ADDENDUM NO. 01

Clark-Pleasant WCHS Phase 4
300 E Main St.
Whiteland, IN 46184

This Addendum consists of Pages ADD 1-1 through ADD 1 - 2 and attached Lancer Associates of Architects, Addendum No. 01, October 23, 2025, consisting of 6 pages and 38 drawings.

1 DEMOLITION PLAN - FIRST FLOOR - UNIT A1
SCALE: 1/8" = 1'-0"

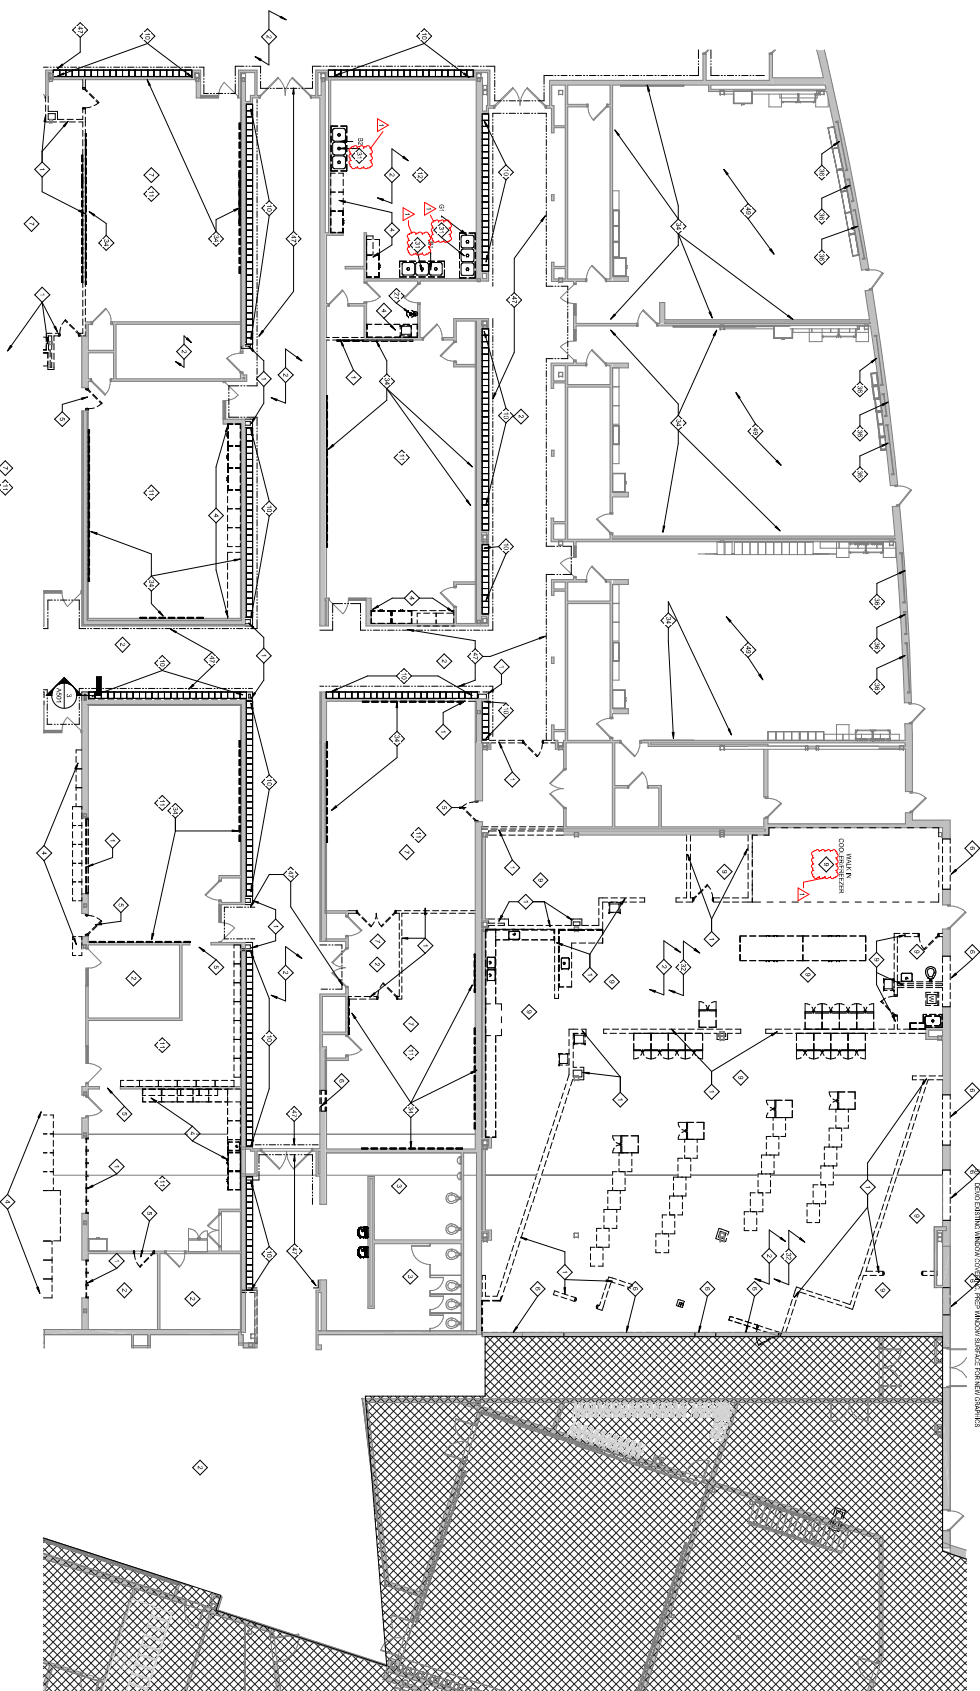
1. AD101A.1 – DEMOLITION PLAN – FIRST FLOOR – UNIT A1
- Modified note 47 added not 50 and 51
2. AD101A.2 – DEMOLITION PLAN – FIRST FLOOR – UNIT A2
- Modified note 31. Added note 9 for walk in cooler/freezer
3. AD101D – DEMOLITION PLAN – FIRST FLOOR – UNIT D

AD101D

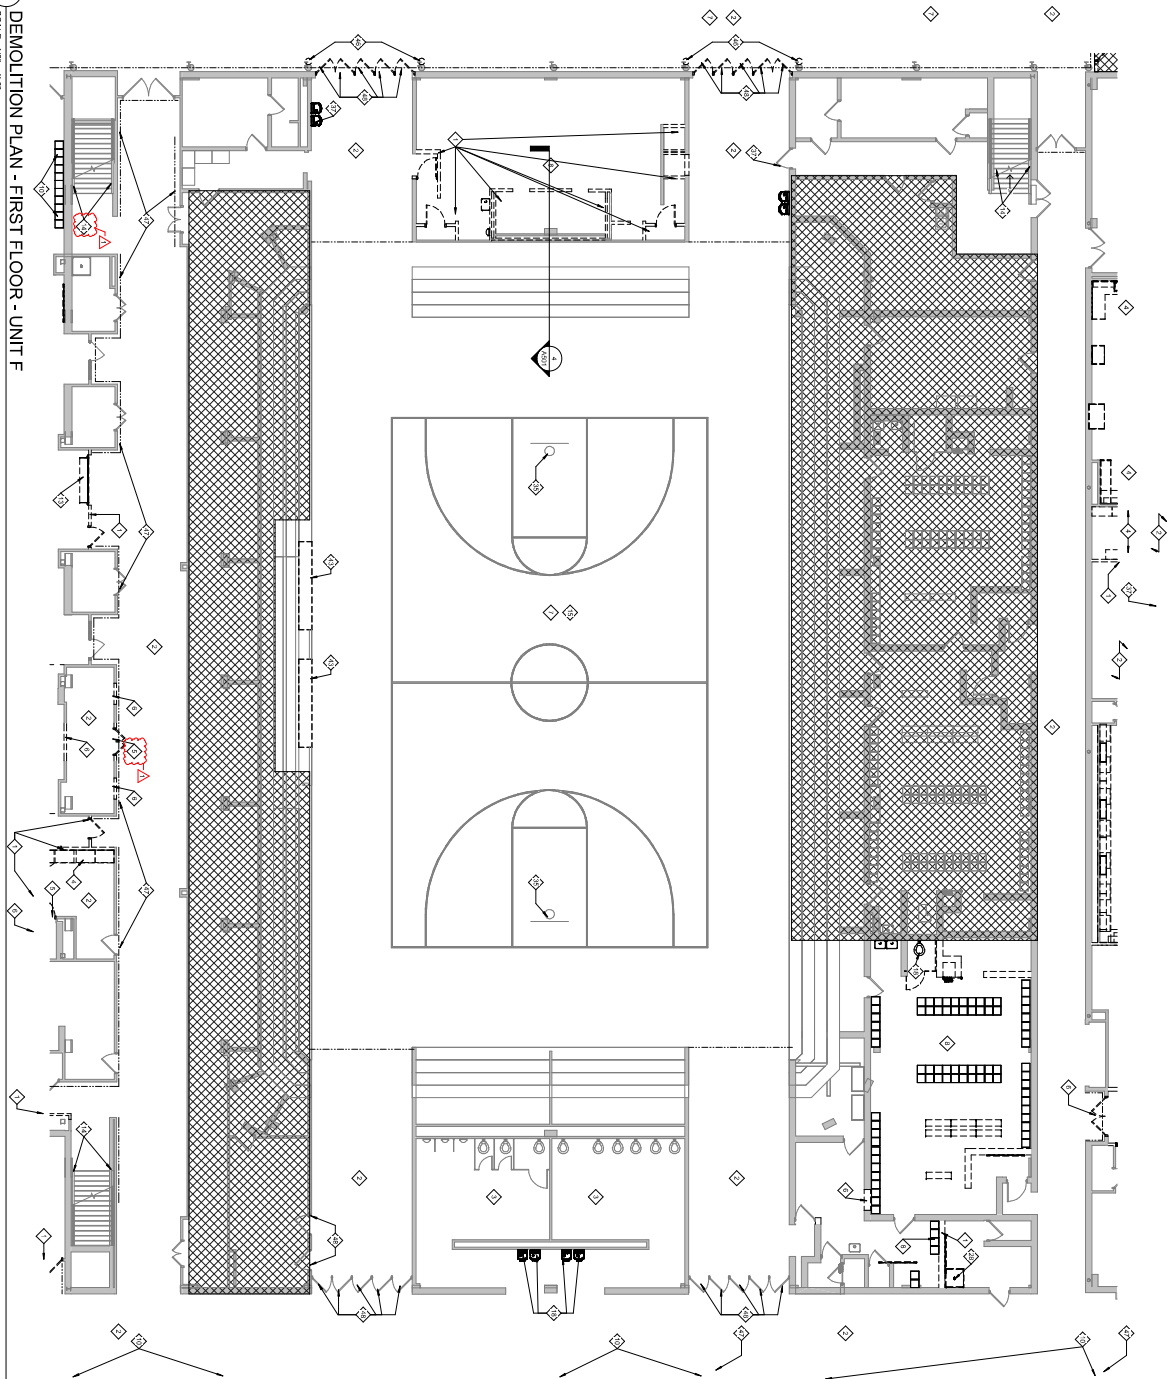
- Added note 19
 - Added existing terrazzo logo area.
4. AD101E.1 – DEMOLITION PLAN – FIRST FLOOR – UNIT E.1
 - Modified note 14, and changed to note 5 from 6.

AD101H

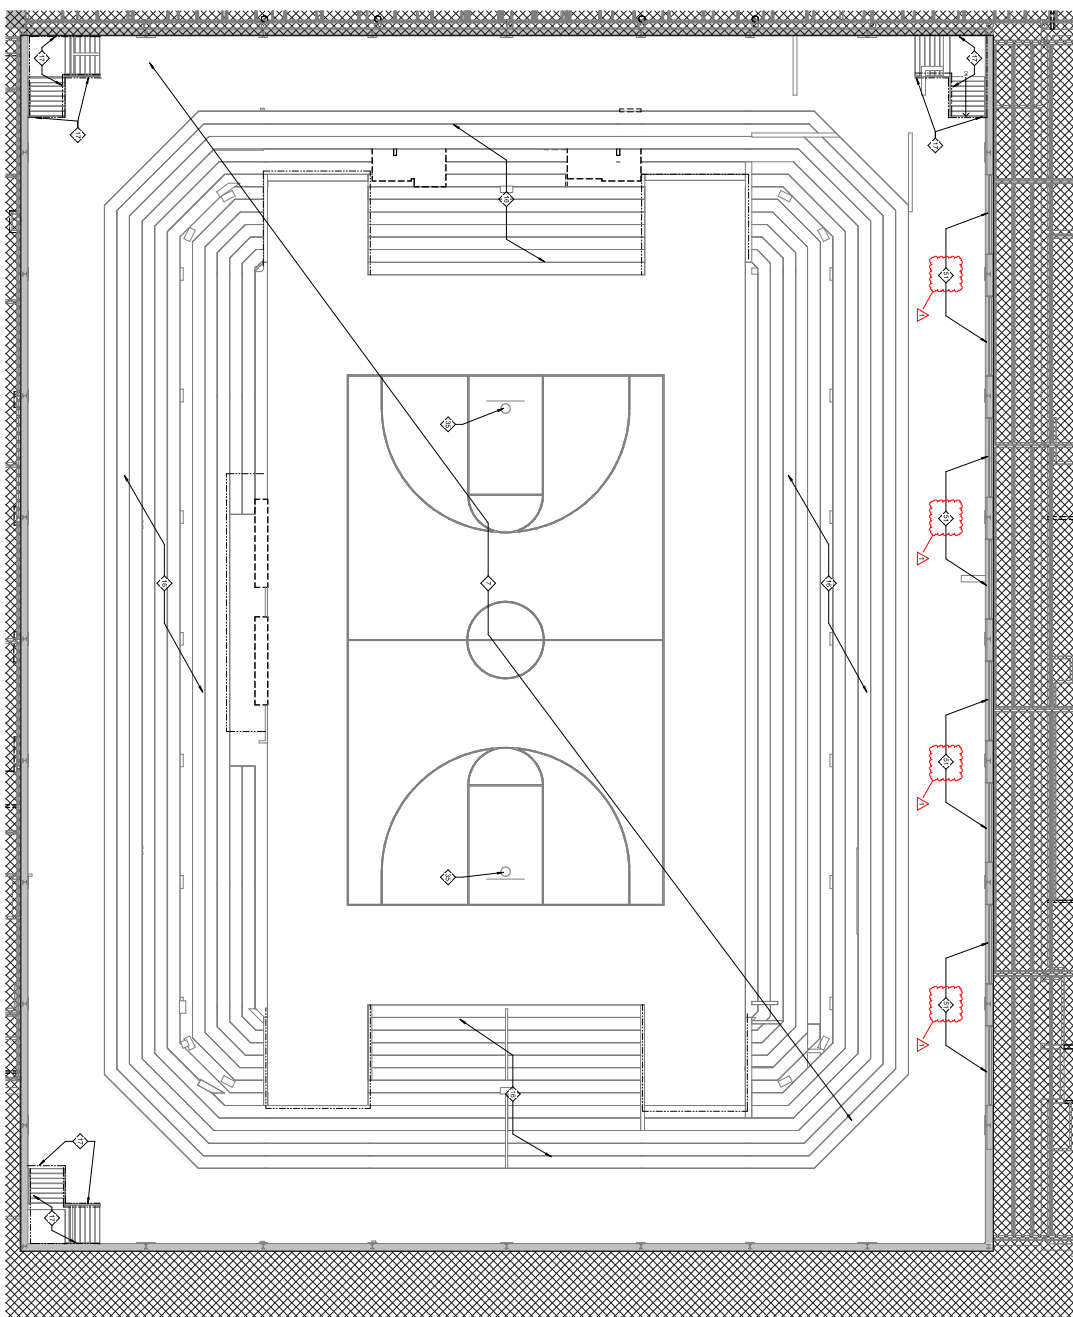
- Added note 50, change note 47 to 50. Removed note 5.
 7. AD101H – DEMOLITION PLAN – FIRST FLOOR – UNIT H
 - Added note 50. Change note 47 to 50.
 8. AD102F – DEMOLITION PLAN – SECOND FLOOR – UNIT F

1 REFLECTED CEILING PLAN - FIRST FLOOR - UNIT G.2

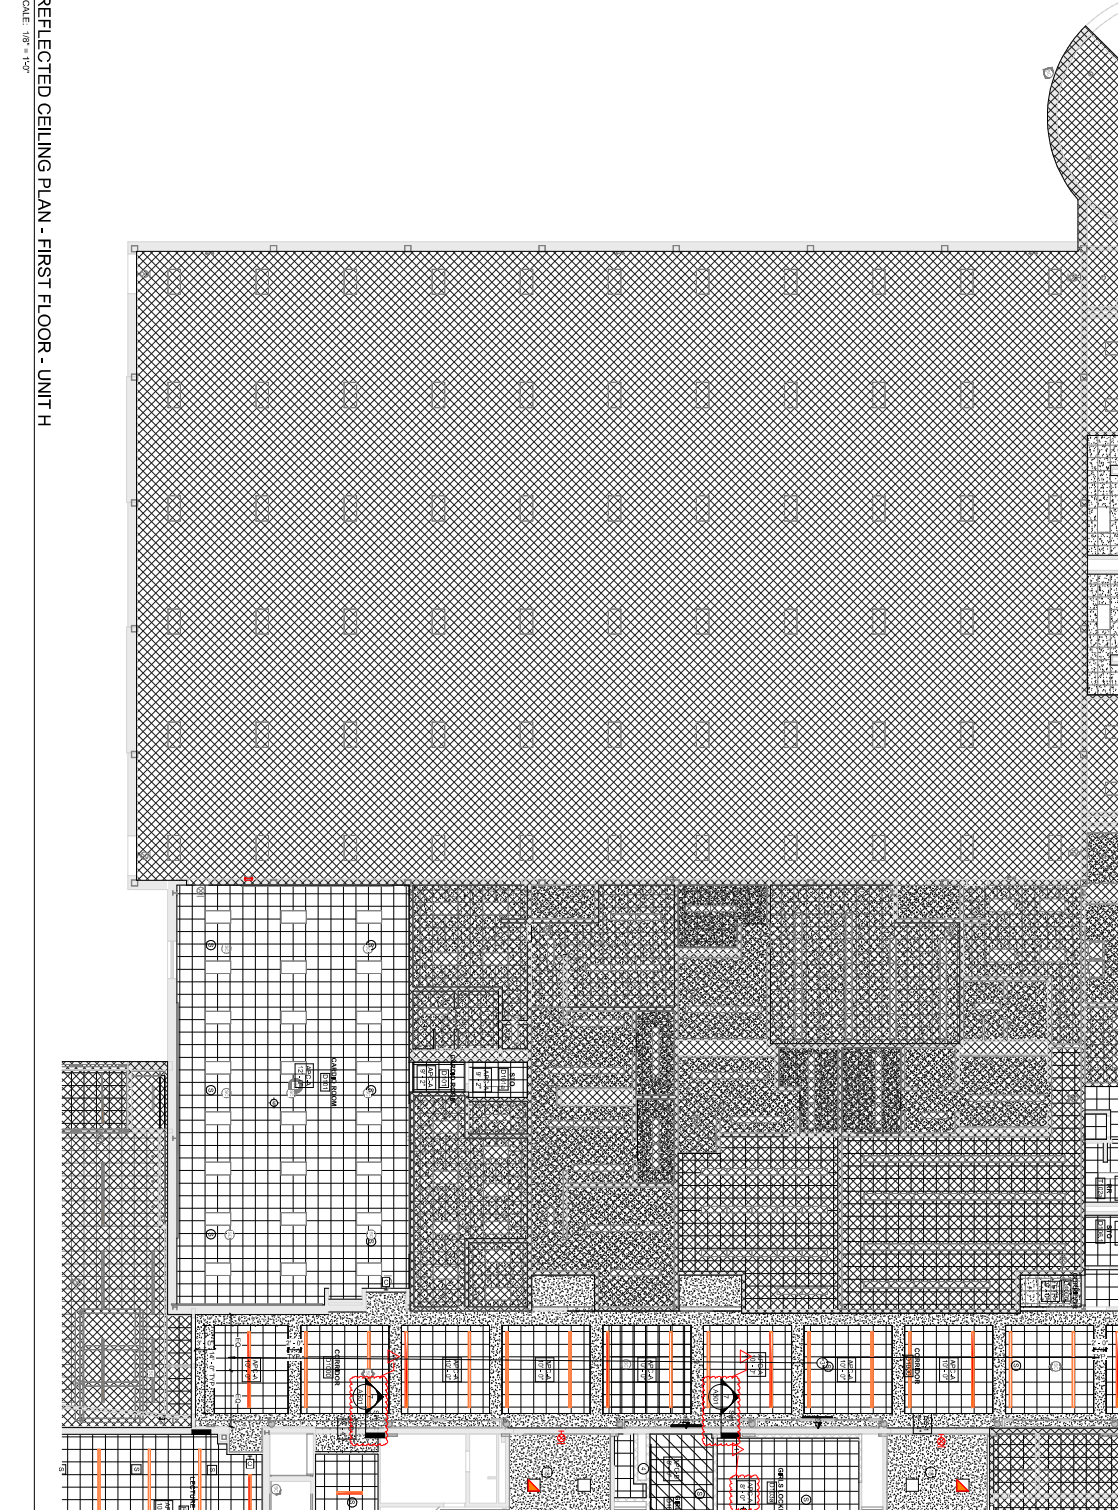
- Added detail 7/A501 Sim
- 18.A121F – REFLECTED CEILING PLAN – FIRST FLOOR – UNIT F
 - Added detail 7/A501 Sim
- 19.A121G.2 – REFLECTED CEILING PLAN – FIRST FLOOR – UNIT G.2

- Added detail 7/A501 Sim. Changed APC-A from 9' to 10'
- 20.A121H – REFLECTED CEILING PLAN – FIRST FLOOR – UNIT H
 - Added detail 7/A501 Sim
- 21.A122D – REFLECTED CEILING PLAN – SECOND FLOOR – UNIT D

A721A.2

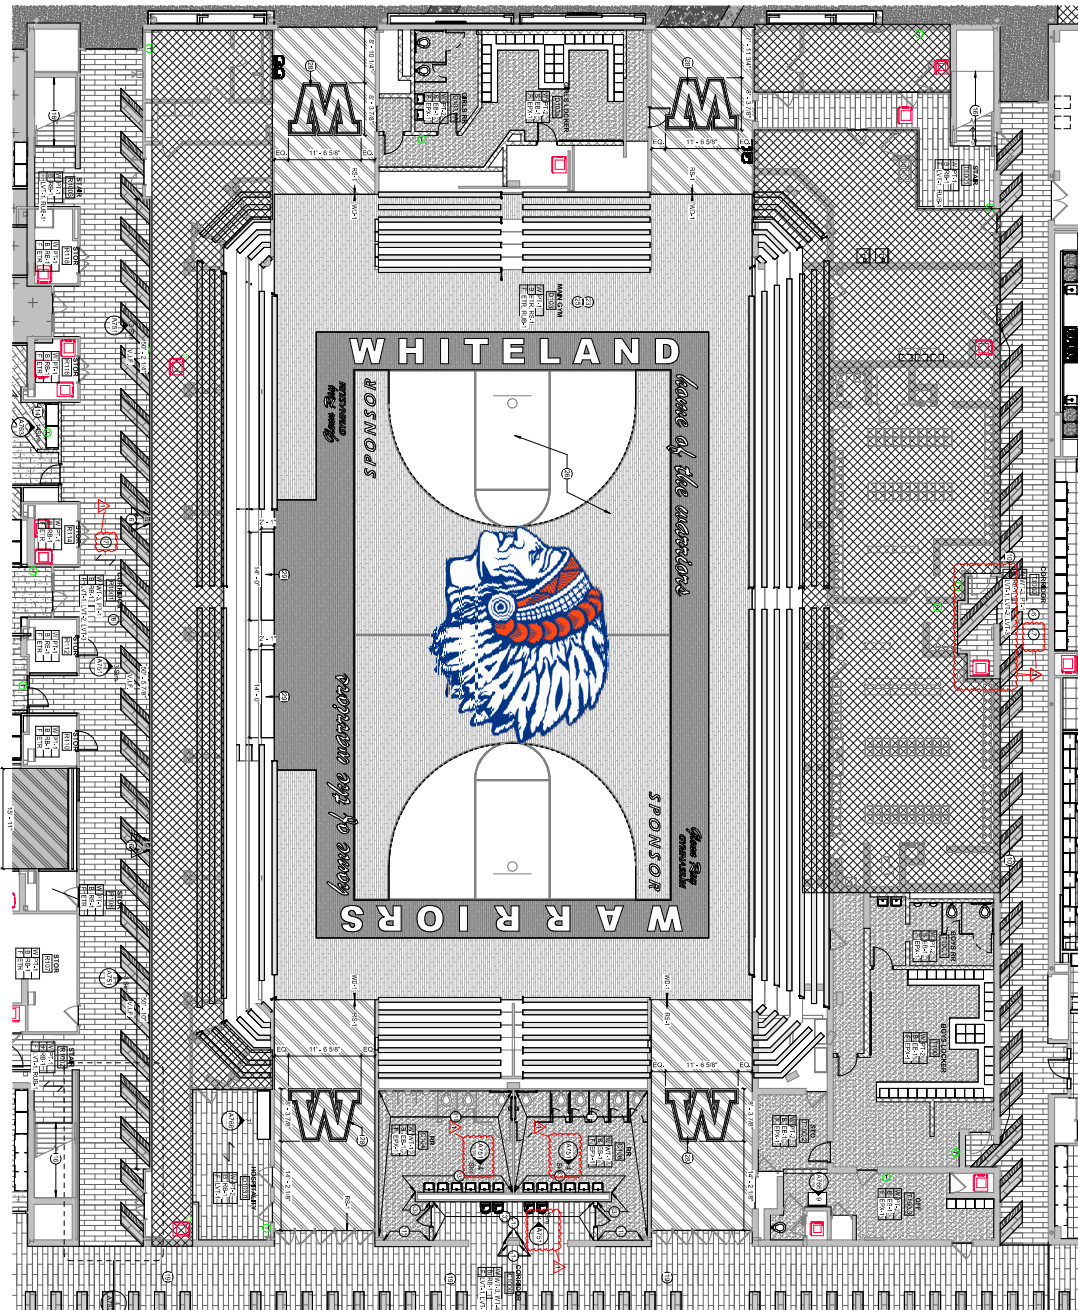
- 26.A721A.1 – INTERIOR FINISH PLAN – FIRST FLOOR – UNIT A.1
 - Revised LVT-2, LVT-1 callouts in Corridor U1001.
- 27.A721A.2 – INTERIOR FINISH PLAN – FIRST FLOOR – UNIT A.2

- Revised Corridor V1000 wall material within finish tag to be “WT-3, PT-1.” Removed WT-4.
 - Added interior elevation 7/A751 for south wall of Corridor V1000.

- Added interior elevations 4/A751, 5/A751, and 6/A751. Reference interior elevations 4/A751, 5/A751, and 6/A751 to be typical of all restroom wall tile areas.

FIRST FLOOR DISTRIBUTION PLAN - UNIT E2

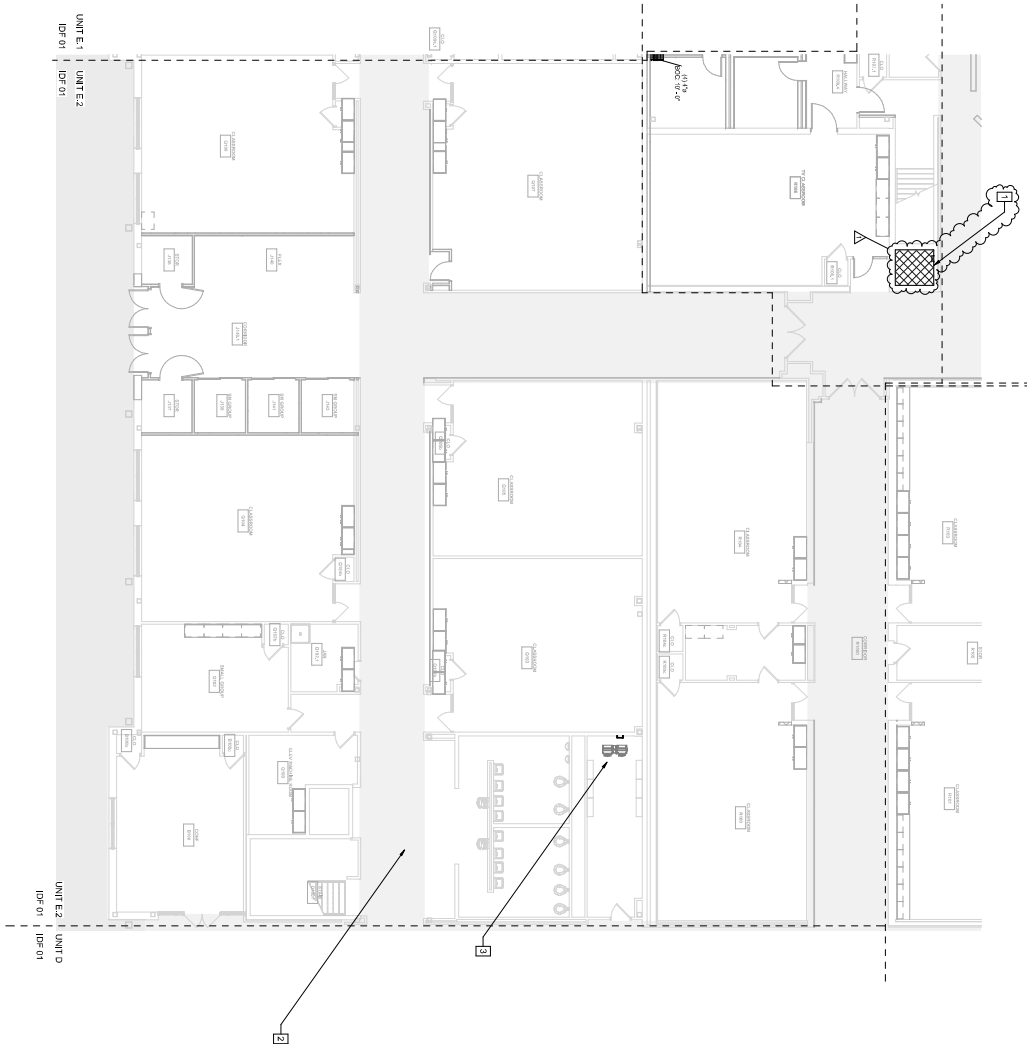
- 2) SHEET T101E.2 – FIRST FLOOR DISTRIBUTION PLAN – UNIT E.2
 - a) Updated sheet note #1 to add requirement for additional wall mounted telecom equipment rack to be required.

FIRST FLOOR
TECHNOLOGY
PLAN - UNIT A.2

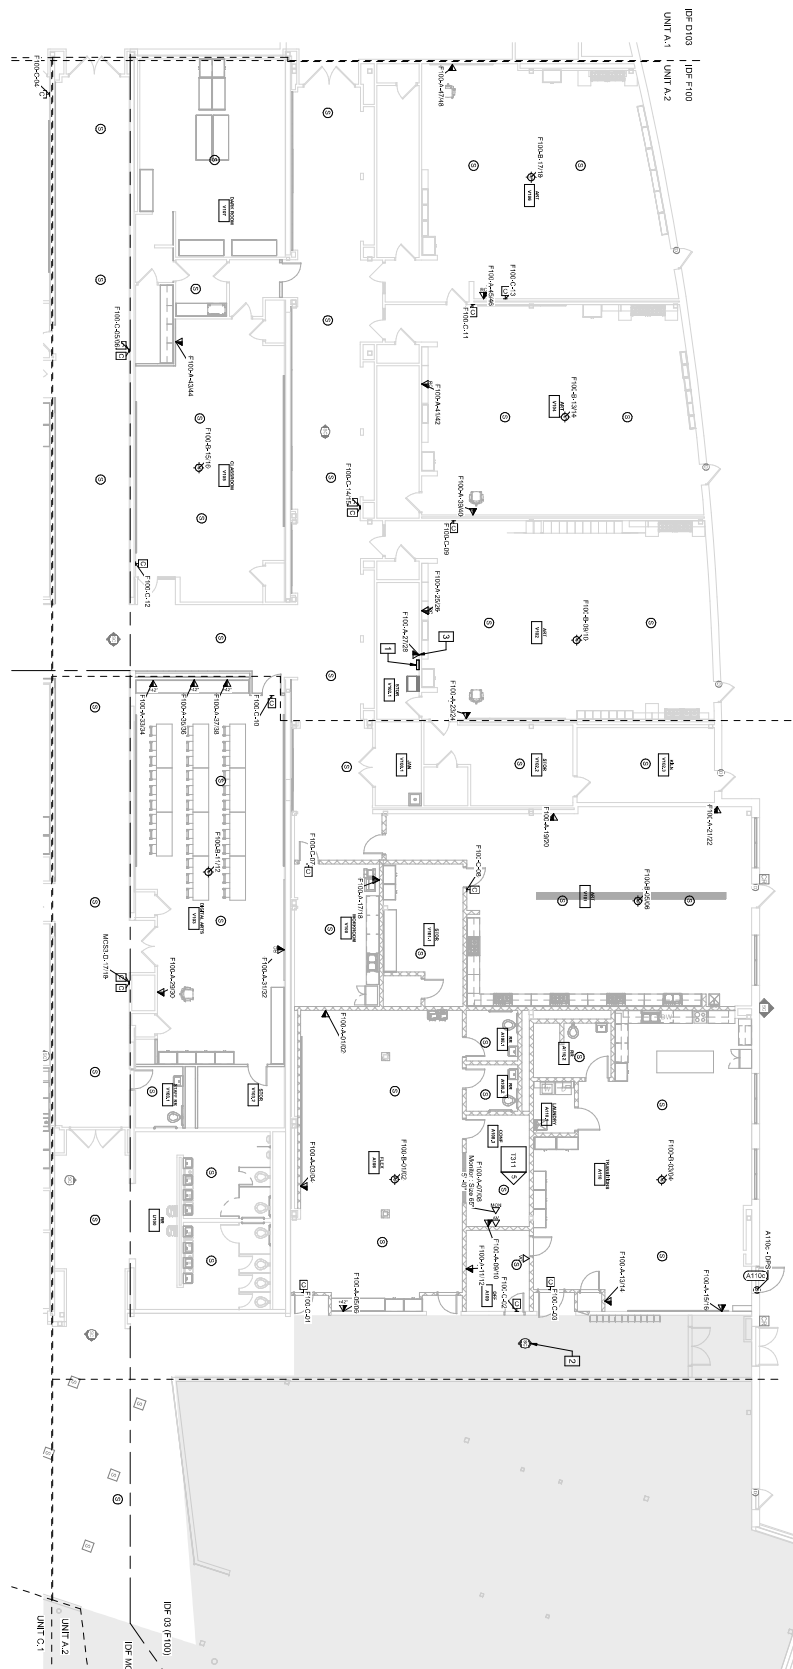
- 3) SHEET T201A.1 – FIRST FLOOR TECHNOLOGY PLAN – UNIT A.1
 - a) Shifted data tags to improve device visibility on sheet.
- 4) SHEET T201A.2 – FIRST FLOOR TECHNOLOGY PLAN – UNIT A.2

- a) Shifted data tags to improve device visibility on sheet.
- 5) SHEET T201C.1 – FIRST FLOOR TECHNOLOGY PLAN – UNIT C.1
 - a) Shifted data tags to improve device visibility on sheet.
